RS-20-019

Quad Cities Nuclear Power Station, Units 1 and 2  
Renewed Facility Operating License Nos. DPR-29 and DPR-30  
NRC Docket Nos. 50-254 and 50-265

Subject: Response to Request for Additional Information for the License Amendment Request to Change Technical Specifications to Increase Allowable MSIV Leakage Rates and Revise Secondary Containment Surveillance

1. Response to NRC ARCB Request for Additional Information
2. QDC-0000-N-1481, Revision 4, Quad Cities Units 1 & 2 Post-LOCA EAB, LPZ, and CR Dose - AST Analysis

**Figure RAI-3b: Modified Nodalization for a Single Steam Line**

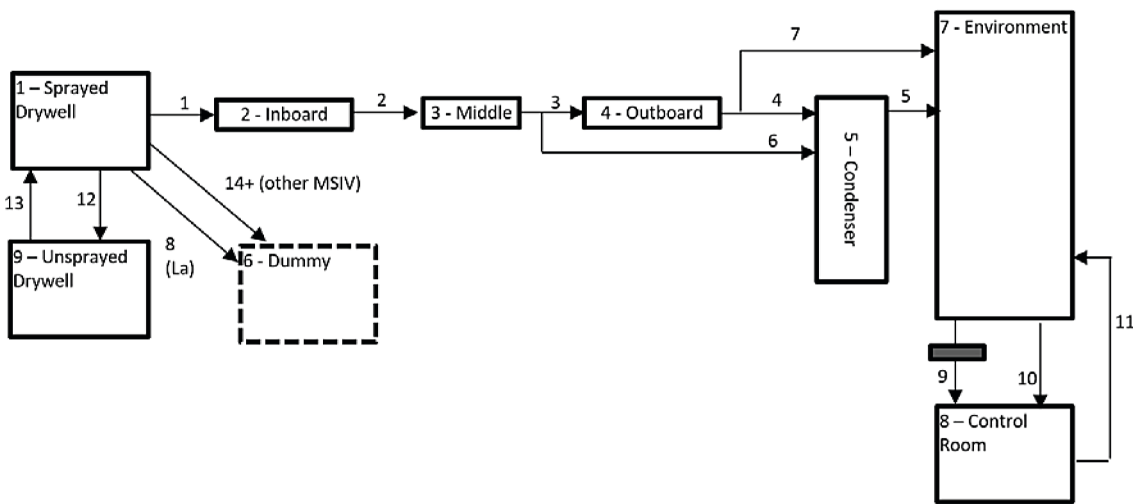
Please provide justification as to why the current aerosol settling velocity and model to credit sprays in the QCNPS design is consistent with Reg 1.183, Revision 0. Please include sufficient technical detail to enable the NRC staff to perform an independent assessment on this aerosol settling velocity and model, and the subsequent calculated control room and offsite doses.

The sensitivity analysis modified the nodalization of the main steam line to overcome limitations of the RADTRAD code. The Unit 1 QDC-0000-N-1481 nodalization was modified to separately model each of the four main steam lines as shown in Figure RAI-3b. As a result, each sensitivity case includes four RADTRAD models, one for each line with three well-mixed nodes per line. The outboard steam line up to the turbine stop valve at QCNPS is seismically qualified, so including holdup and deposition in this piping as part of the outboard compartment (third well-mixed node in Figure RAI-3b) conforms with the requirements of RG 1.183.
